**Subject:** Response to Nuclear Regulatory Commission Request for Additional Information  
Re: Request for Relief for the Fourth 10-Year Inservice Inspection Program (TAC  
No. ME7875)  
Cooper Nuclear Station, Docket No. 50-298, DPR-46

**Response to Nuclear Regulatory Commission Request for Additional Information  
Re: Request for Relief for the Fourth 10-Year Inservice Inspection Program  
(TAC No. ME7875)**

Cooper Nuclear Station, Docket No. 50-298, DPR-46

**FIGURE**

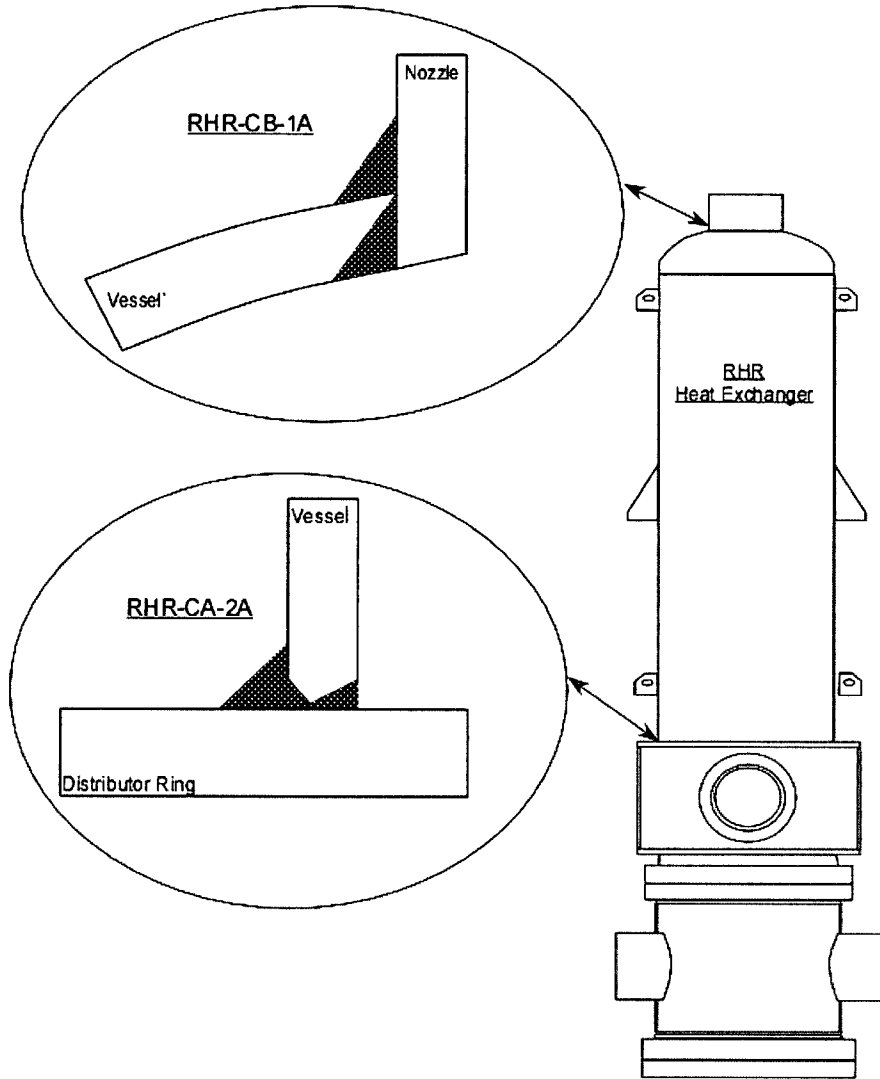
*Please provide a diagram of the residual heat removal vessel on which the examinations were performed indicating on the diagram where the welds of interest are located.*

### Response #4

See following Figure:
